# Access Compliance Report

### (Curb Ramps)

| Intersection ID: 48792                  | Main Street: WOODLAND_WATCH_CT | Cross Street: COMMUNITY_HOUSE_RD | Location: SW                            |
| ADA ID: E5E9A9F2D48B                    | Ramp Type: Perp                | Initial Pass/Fail: Fail          | Overall Compliance: No                  |

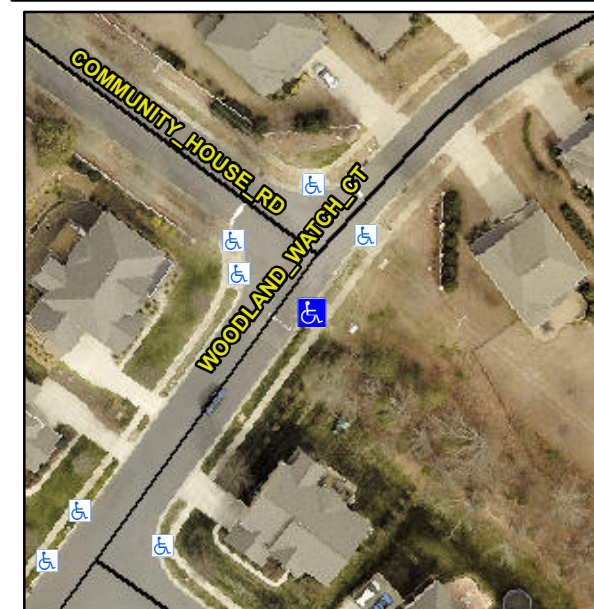
**Not Found, R304.2.2, R304.5.3**

| Compliance | Description           | Data  | Compliance | Description                 | Data |
|------------|-----------------------|-------|------------|-----------------------------|------|
| N/A        | Ramp Length (in)      | 73.0  | No         | Ramp Slope (%)              | 8.6  |
| Yes        | Ramp Width (in)       | 48.0  | No         | Ramp XSlope (%)             | 6.4  |

**Remove & Replace Entire Ramp.**
